DATE:

File: AR 15-03

Harrison Duplexes, 930 East Lassen Avenue, APN 007-320-032

SUBJECT: HARRISON DUPLEXES
ARHPB PROJECT DESCRIPTION

ATTACHMENT D. >

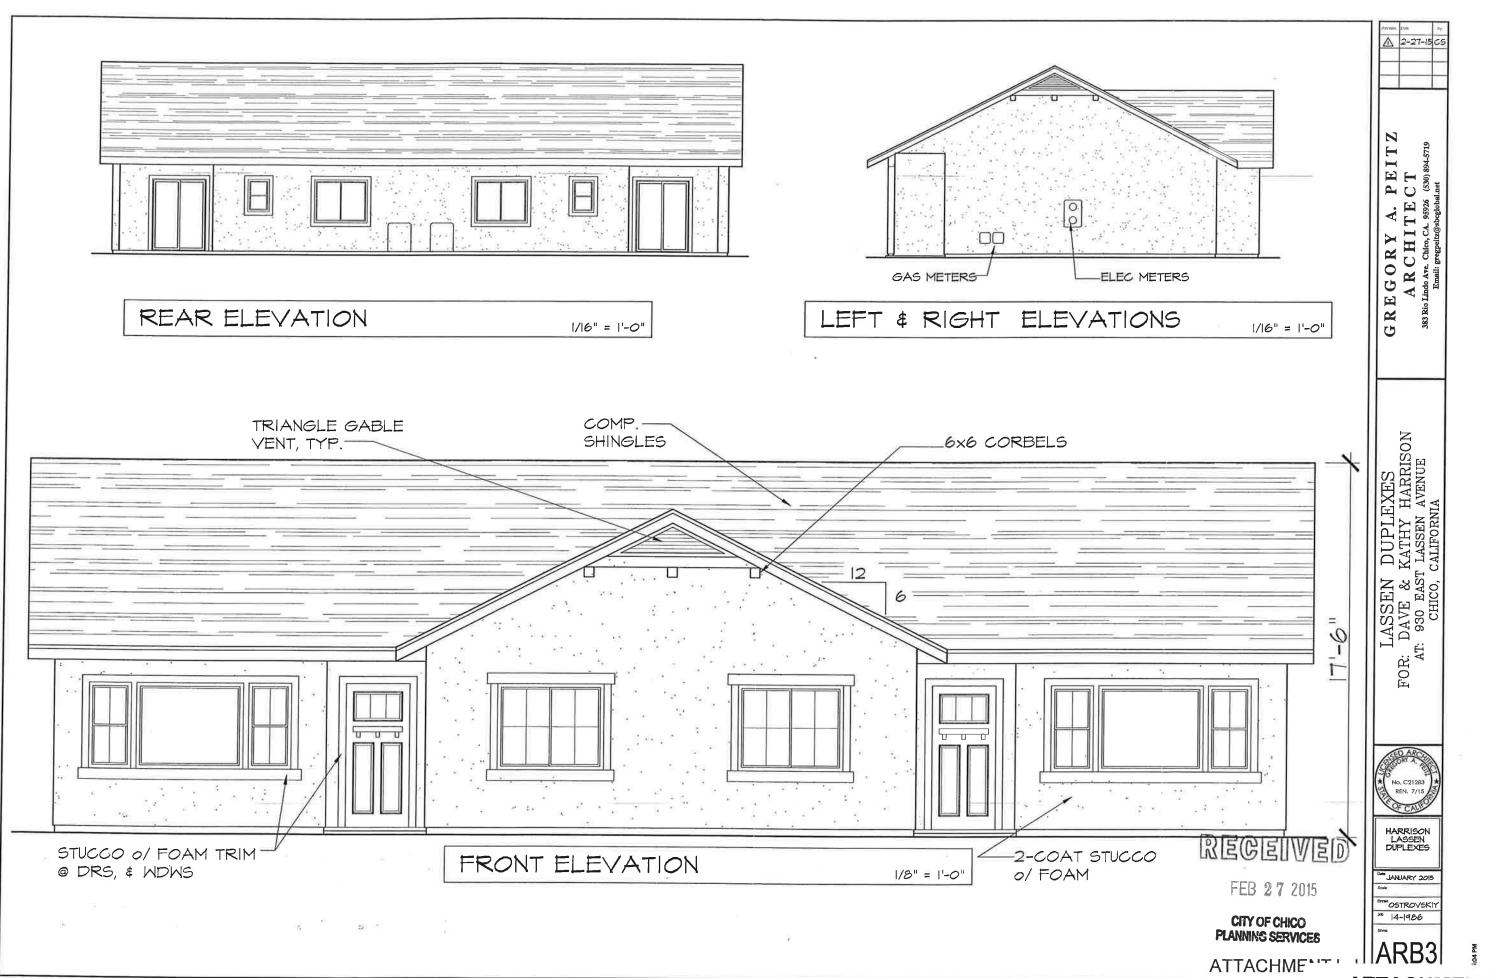
The buildings exhibit a contemporary ranch style with craftsman elements that include 6x6 corbels at gables, gable vents and grid patterns windows. Staff recommends the Craftsman style be more pronounced by extending eaves at least one foot.

The applicant is proposing a color pallet made of beige and brown tones, which have become common in Chico. Staff believes that the project can be enhanced with the introduction of different color spectrum.

Due to the site plan's orientation, two duplex structures are placed so that the side of the structures front Lassen Avenue. Design Guideline 4.1.3 states that projects orient multiple-family residential development to the street and pedestrians. Staff recommends that the Board discuss adding a design element, such as windows or other element, to the southern elevations that face Lassen Avenue.

- 5. Trash enclosure shall be rotated 90 degrees, so that it is further away from the residential unit to the south.
- 6. Structural plans shall be modified to extend the eaves at least one foot.

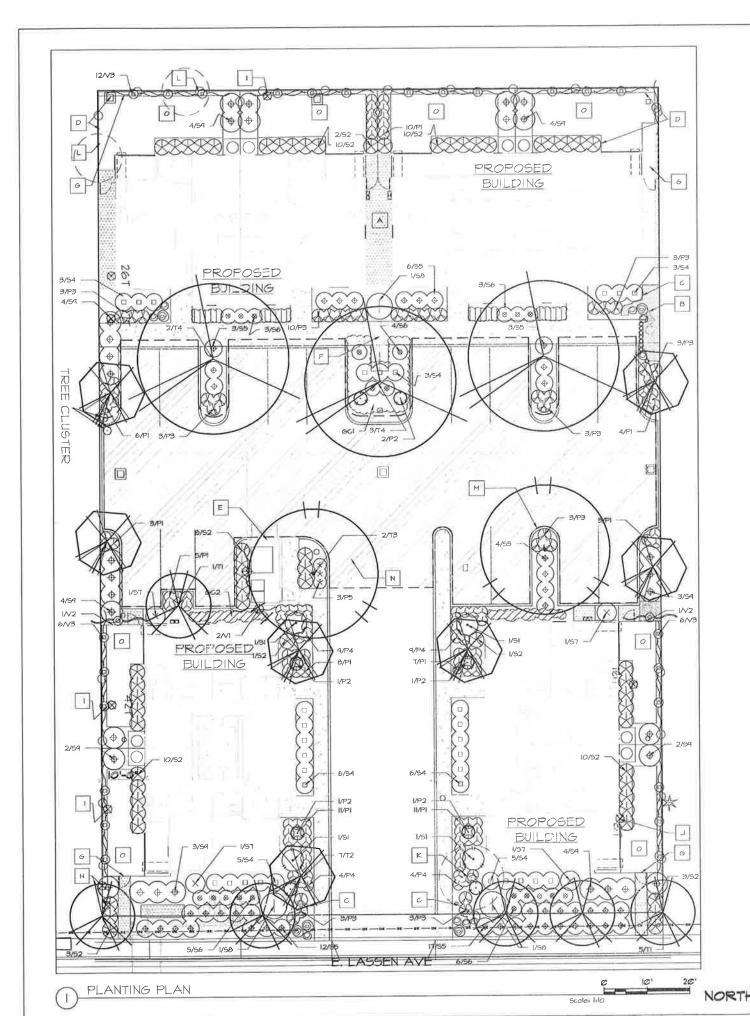
The architect has noted that structural lighting will be recessed over each entrance door. Parking lot lights are noted on the site plan and a detail sheet has been provided

(Attachment F). The height of the parking lot lights are not noted, therefore staff recommends a condition that the parking lot lights not exceed 15 feet to offer pedestrian scale.
